# Motorola Mobility LLC.

## Product Equality Declaration

The differences between AP and previous as below:

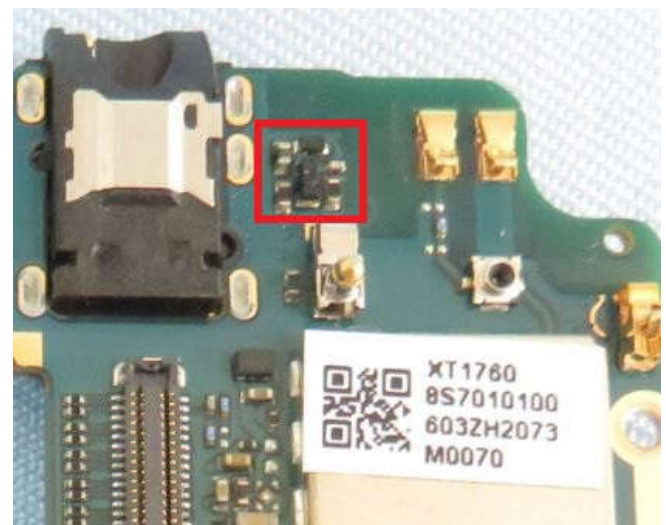
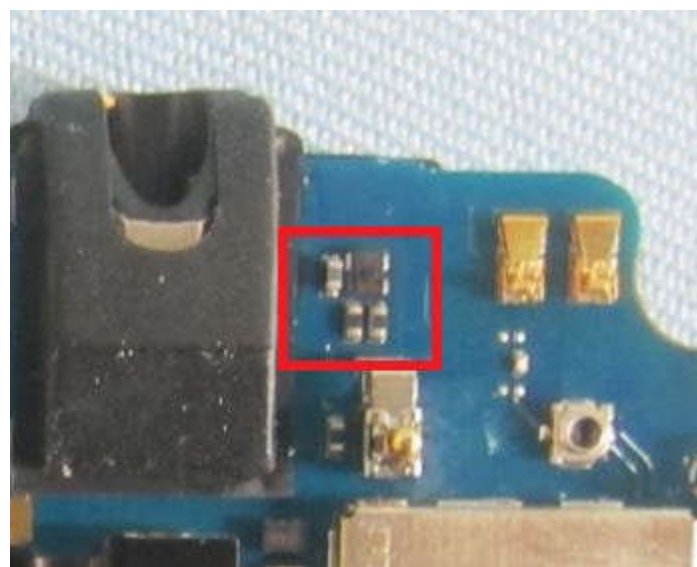
These changes have no effect on RF.

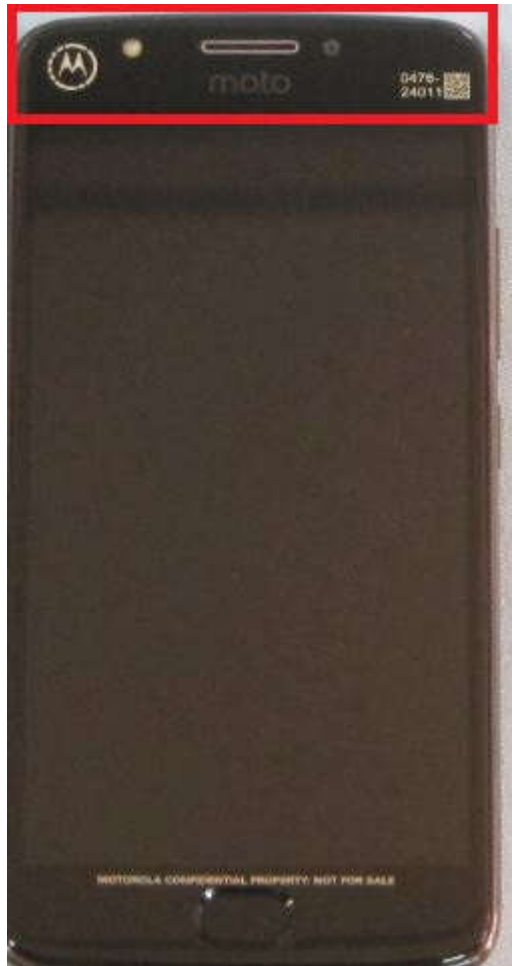
To facilitate material selection and procurement. These changes have no effect on RF.
